Final Drainage Report

# Winsome Subdivision Filing No. 3 El Paso County, Colorado

PCD File No. SF-22-009

Prepared: February 2, 2023

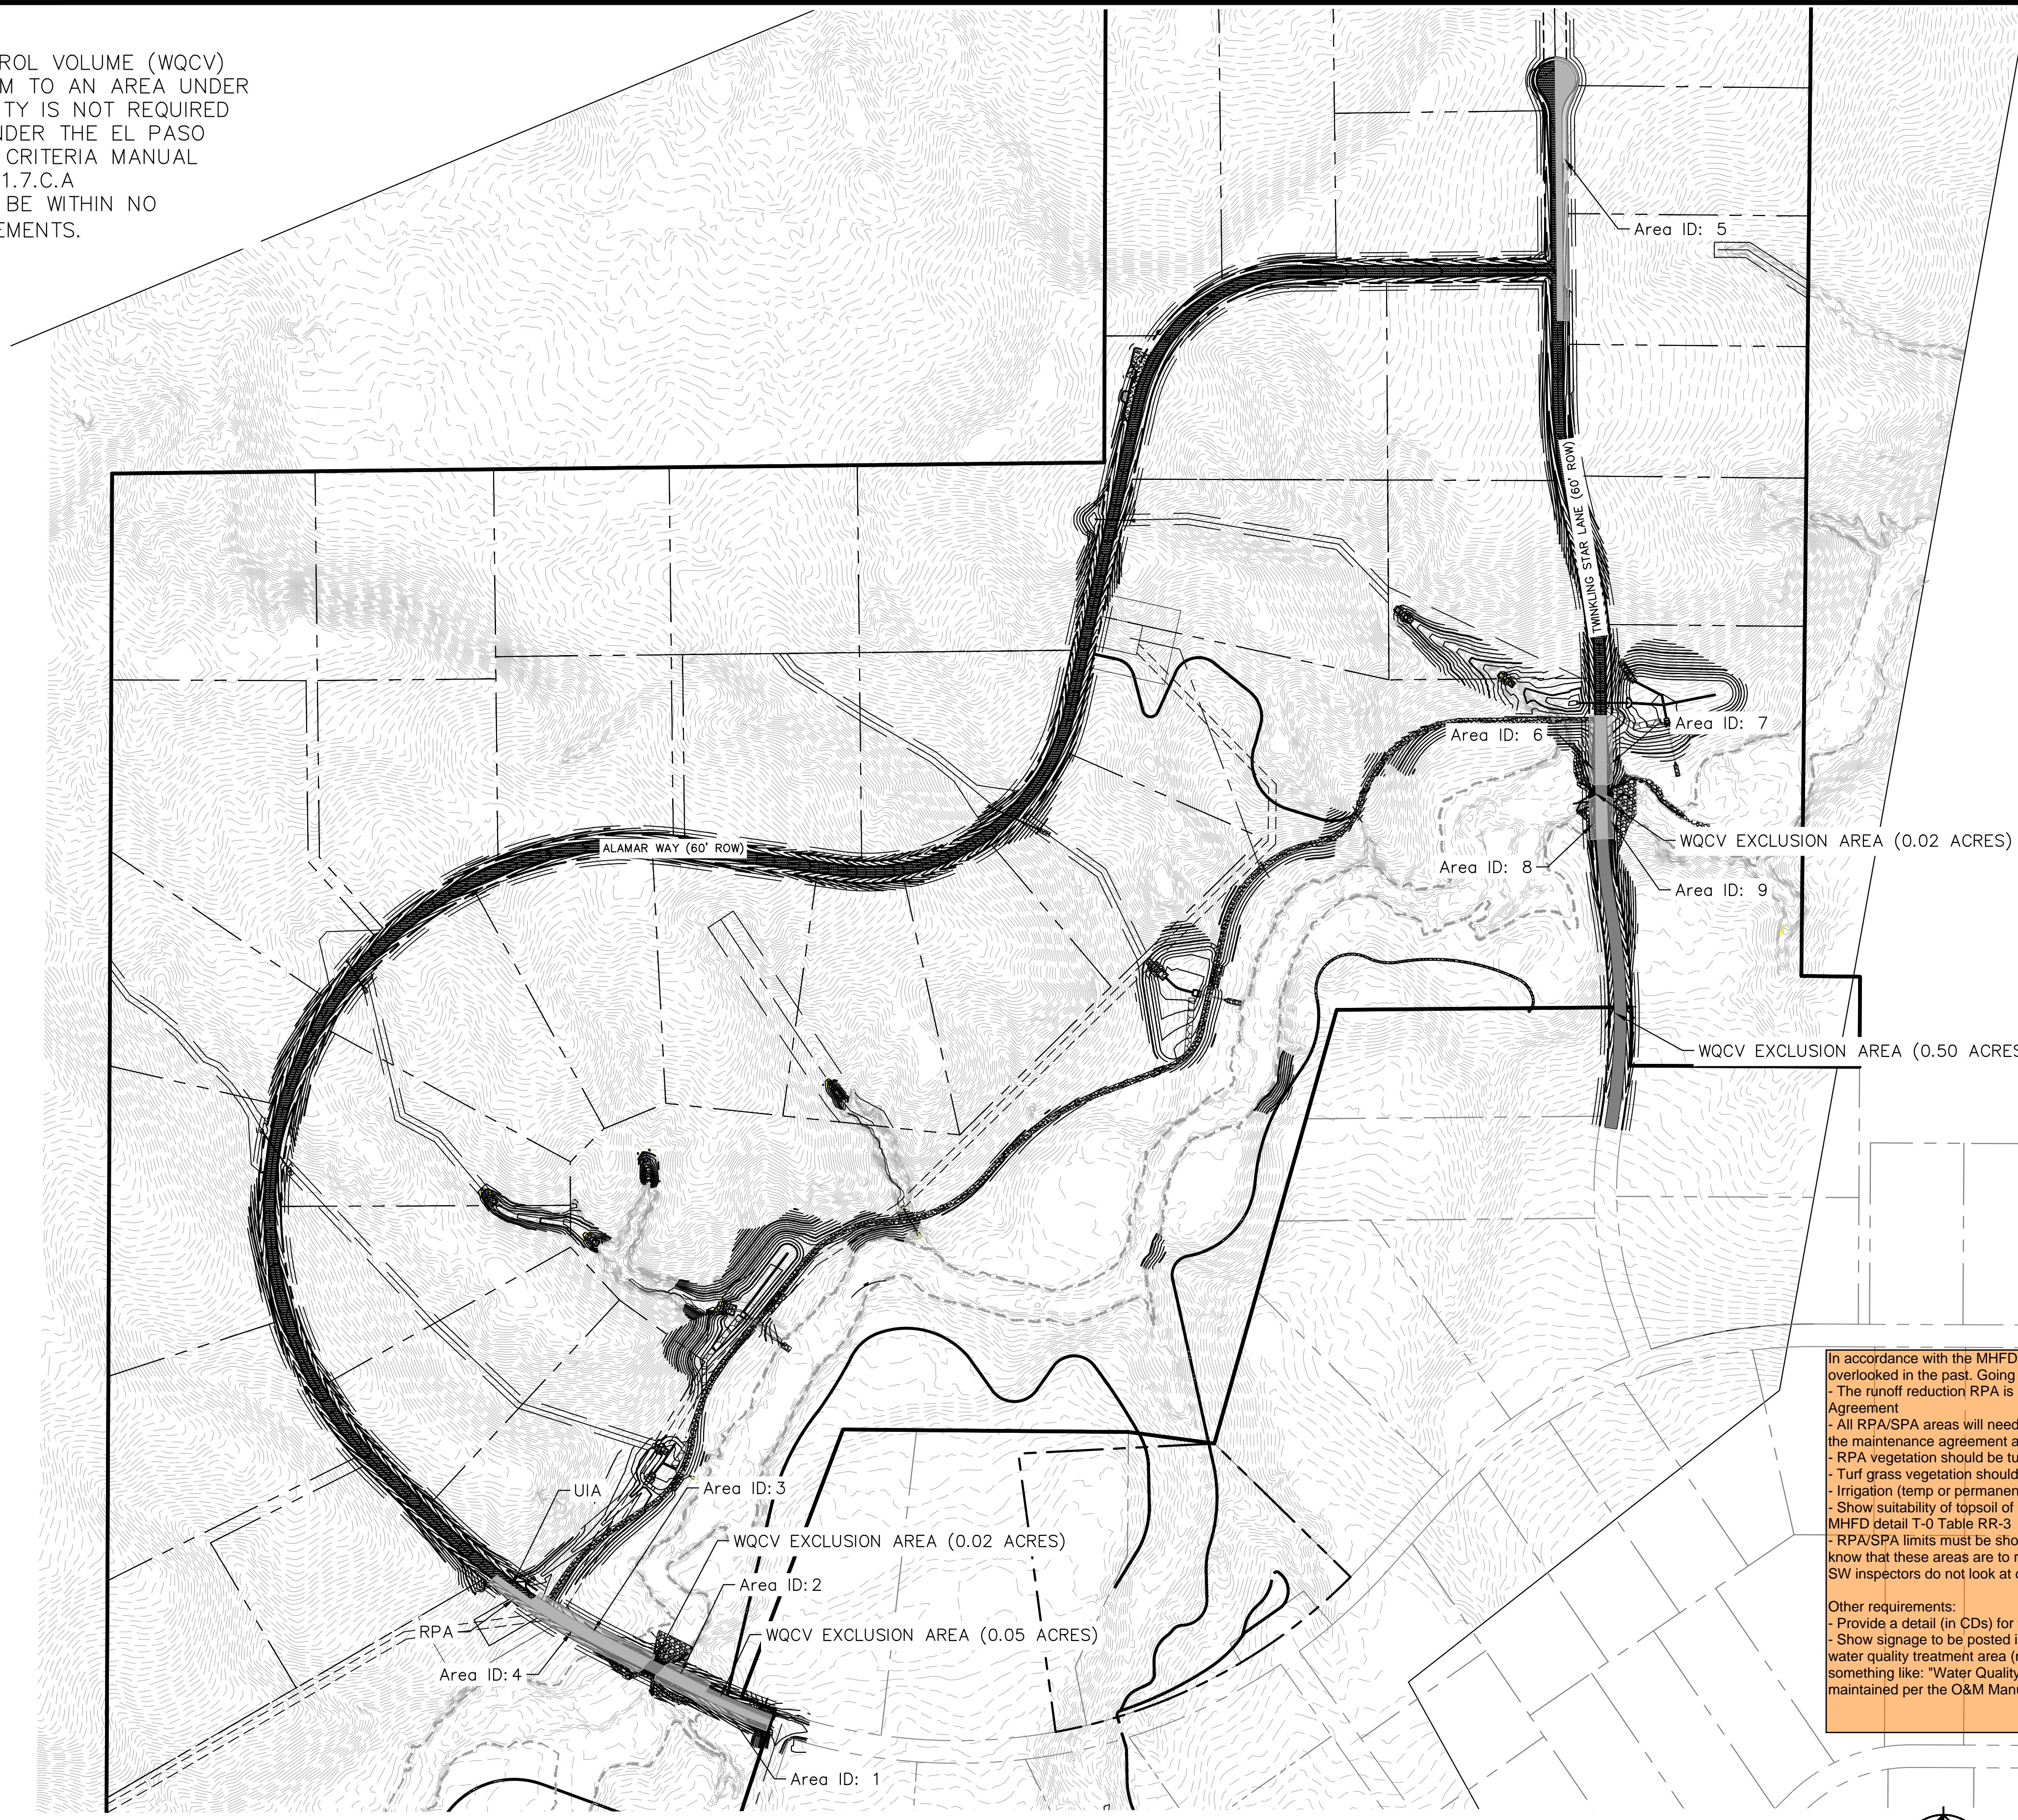
- Irrigation (temp or permanent) is necessary to establish sufficient vegetation and not just weeds.  
 - Show suitability of topsoil of RPA and steps for proper preparation of topsoil per recommendations in MHFD detail T-0 Table RR-3
